INDESIT company

Model type:
AVF88EUTE

Commercial code:
F035913

1140150B Exploded views

n1040376: Drain pump with filter with pin.

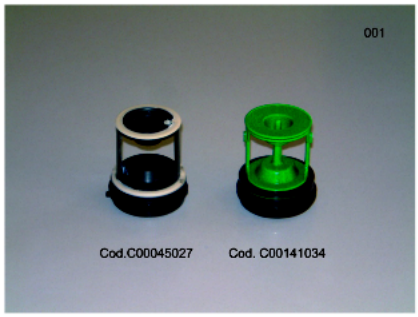
A new drain pump with filter with pin has been introduced progressively as from serial no. 50609.0001.

New parts:
C00119307 - Drain pump with pin filter;
C00141034 - Askoll / Plaset drain pump with pin filter kit (figure 001);

Premodification parts:
C00092264 - Drain pump;
C00045027 - Askoll / Plaset pump filter kit (figure 001);

The new parts can be used on all WASHING MACHINES previously equipped with the premodification parts.
